**SUBJECT: RECALL R10RK BATTERY CABLE ROUTING AT REAR OF
LARGE BATTERY COMPARTMENT**

Battery Cable Routing at Battery Compartment

**Models Affected: 2010 All American (D3) Rear Engine Buses Equipped
With Feature 00156-09 Heavy Duty Battery Compartment**

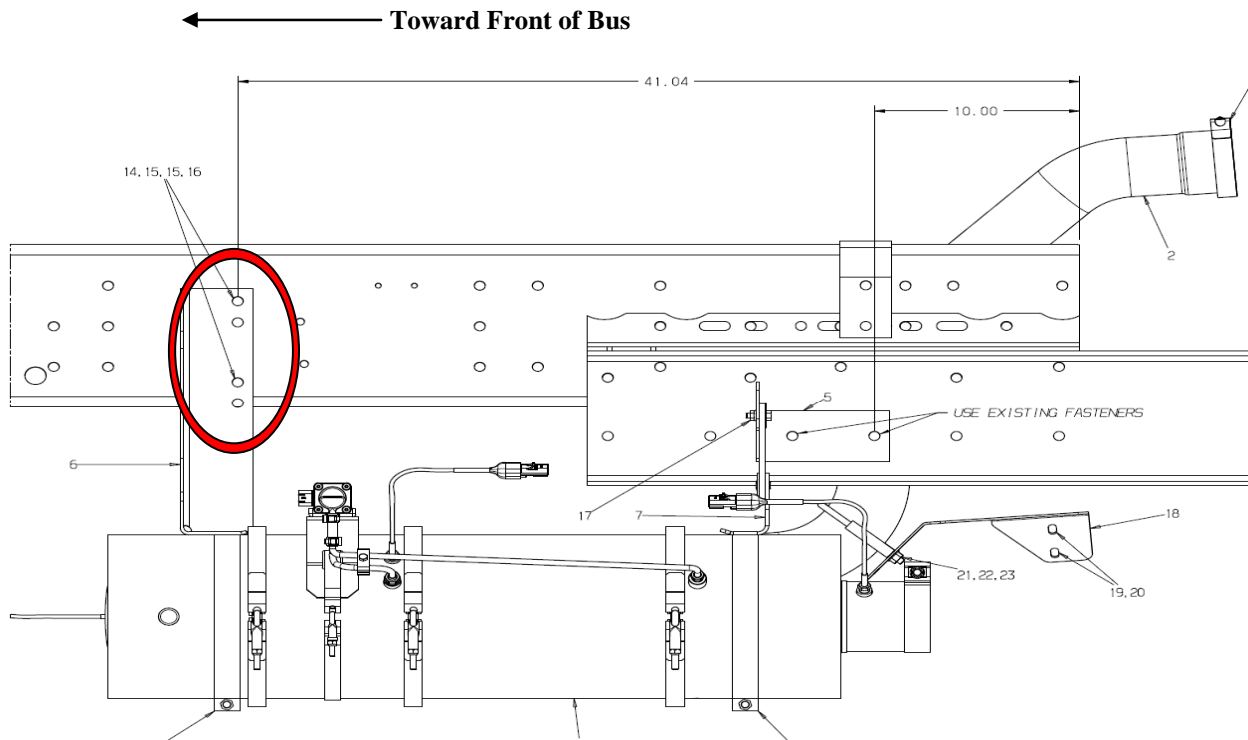
- 6. If any battery cables are pinched between the muffler mounting bracket and the front bottom side of the heavy duty battery compartment (See photos below) remove the clamps and zip strips securing cable, remove cable from between battery box and the muffler mounting bracket, remove loom and inspect cable for damage to insulation.

- 7. If cable is damaged, disconnect other end reference attached diagram D0003543), remove from chassis and replace w/new cable assembly.
- 8. If cable is pinched but not visibly damaged, then reroute cable to rear of heavy duty battery compartment and re-clamp/secure to hold in place per photo on page 1. Reference diagram D0003543 for cable routing.

Note: Cables must be routed/clamped to prevent contact with exhaust muffler. A minimum of 3 inches must be maintained between cables and exhaust muffler.

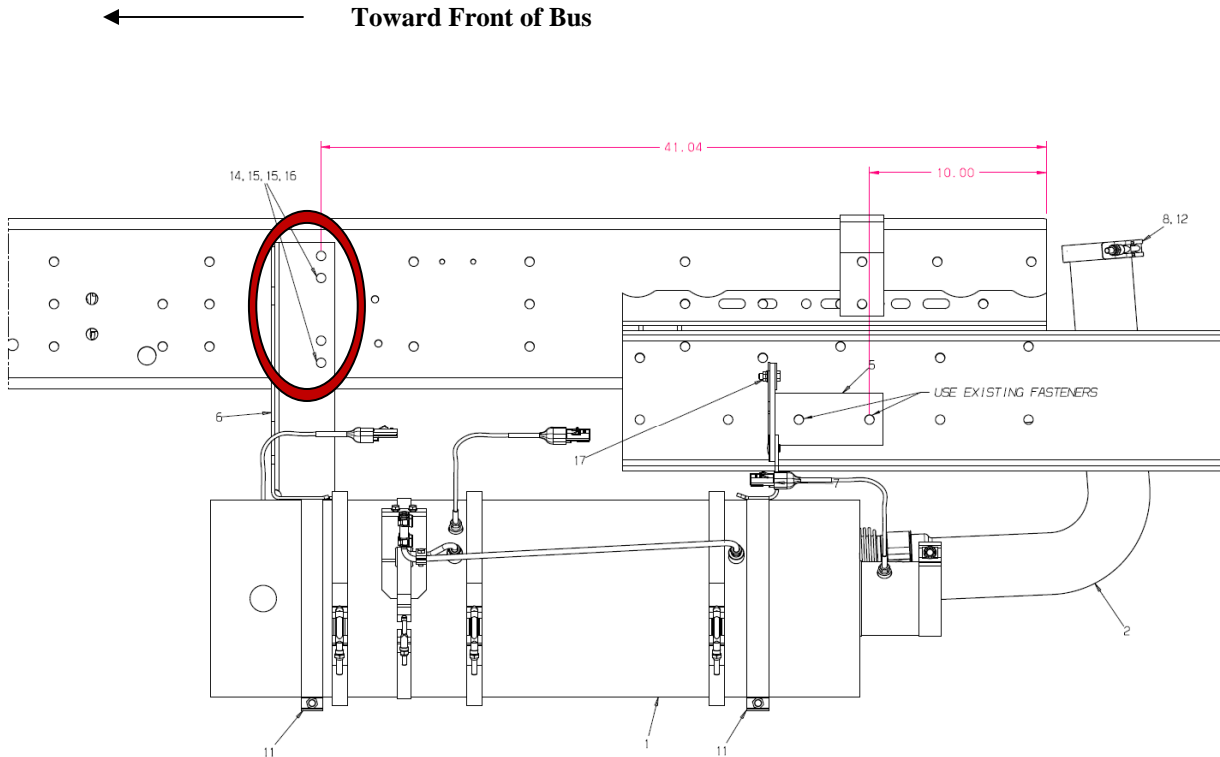
9. If exhaust muffler is contacting the battery compartment, relocate muffler exhaust bracket per diagram below for buses equipped with **Cummins ISB engines**.

Use **upper holes** in the bracket to mount to the **lower frame holes** at 41.04" from the end of frame. *Do not use the frame holes located at 40" from the end of frame.*
